INDESIT company

Model type:
IS70CS

Commercial code:
F030618

CONDENSER MOTOR and COOLING FAN

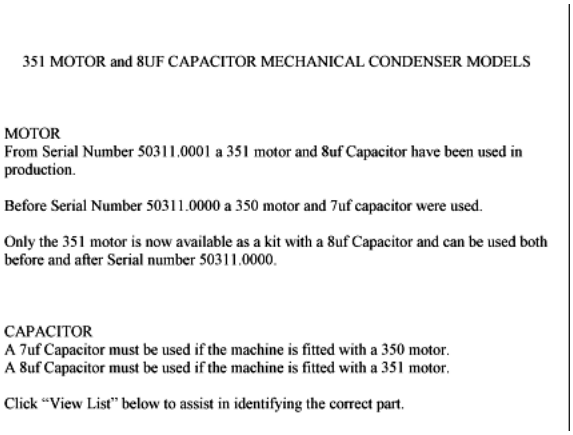
FAN
From Serial number 60907.0001 the fixing dimensions to the motor shaft changed.

With this change to the motor shaft a new version of cooling fan was introduced, the original and new versions of fan are not

interchangeable. The original fan C00207723 (1703002) can only be fitted to a model produced before serial number 60907.0001

A further change has been made to the original fan C00207723 (1703002) this has been replaced in service by a fan that is shorter in length to 72mm part code C00095599. The fitting of this fan does not effect the performance of the condenser drying process.

For 'C' Energy models a change has also been made in production to the fan as fitted from serial number 60907.0001 C00199451 (1703672) this has been replaced by a fan that is shorter in length 72mm part code C00272335. The fitting of this fan does not affect the performance of the condenser drying process.

MOTOR
The service motor type 351 part code C00194688 is used for replacement to all production and is supplied as a kit including the later version fan C00272335 and an 8uf capacitor
